To: T10 Technical Committee
From: Barry Olawsky, HP (barry.olawsky@hp.com)
Date: 3 July 2007
Subject: T10/07-304r0 SAS-2 Zero-Length Test Load Section

Replace the zero-length test load section with the following text and graphics.

Figure 105 — Zero-length test load for transmitter device compliance point

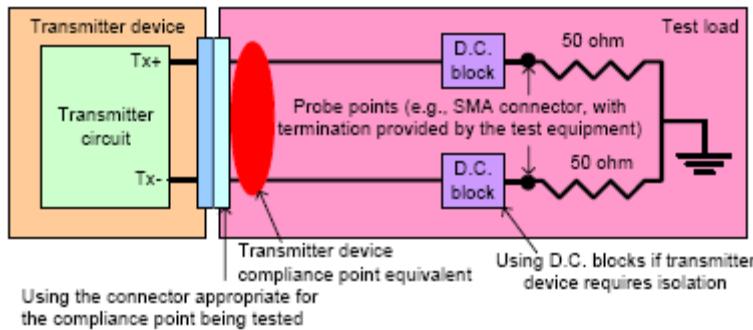
Figure 105 shows the zero-length test load as used for testing a transmitter device compliance point.

Test loads in figures 105 and 106 show ideal designs. Physically implementable designs include insertion loss between the compliance and probe points and return loss due one or more impedance mismatches between the compliance point and 50 ohm terminations points. Also not shown are non-ideal effects of the test equipment such as additional insertion and return loss. Refer to Annex B for de-embedding methods to remove such effects.

Figure 106 — Zero-length test load for receiver device compliance point

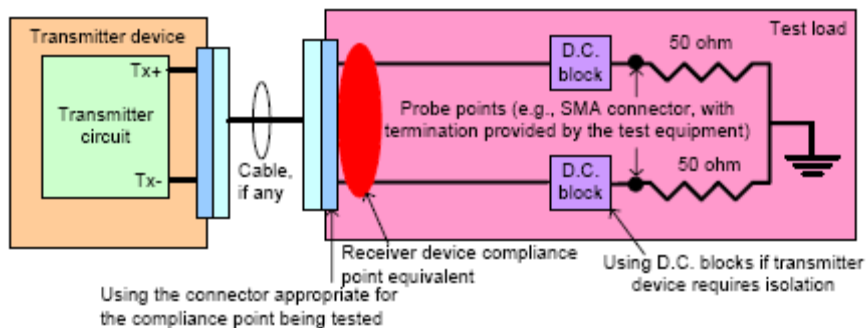
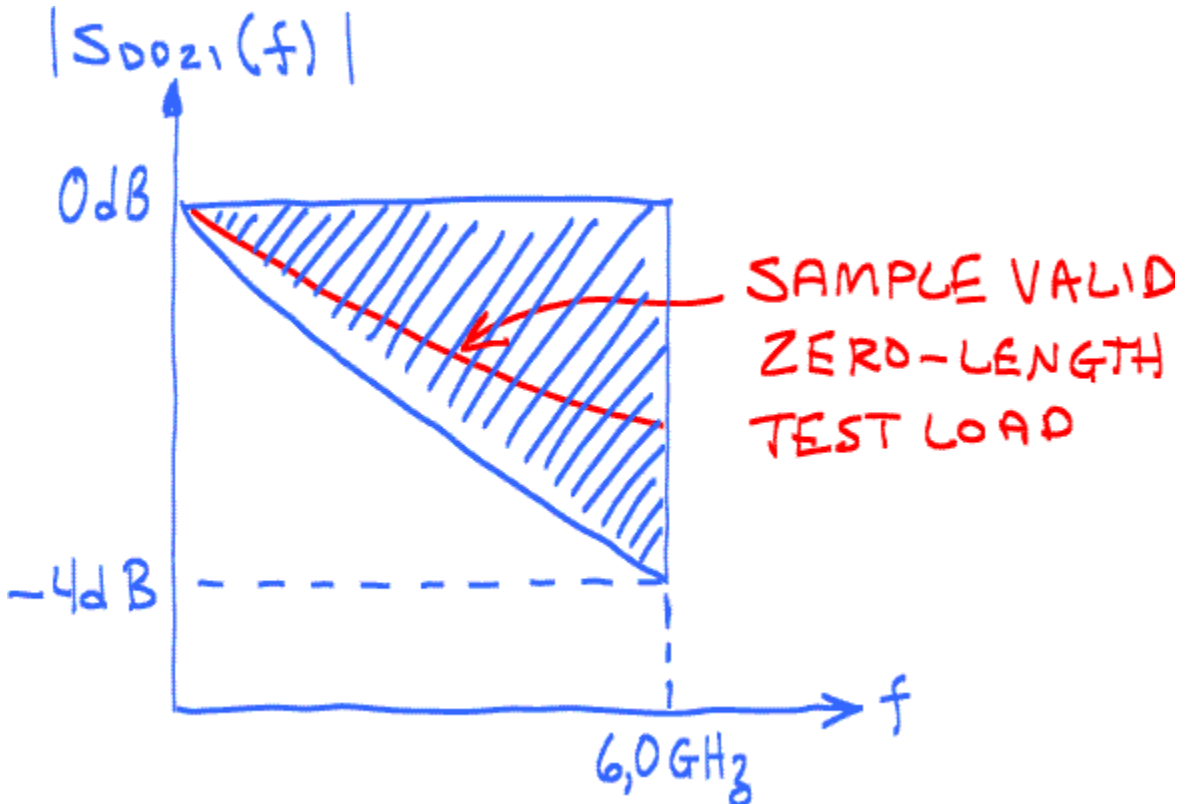
Figure 106 shows the zero-length test load as used for testing a receiver device compliance point.
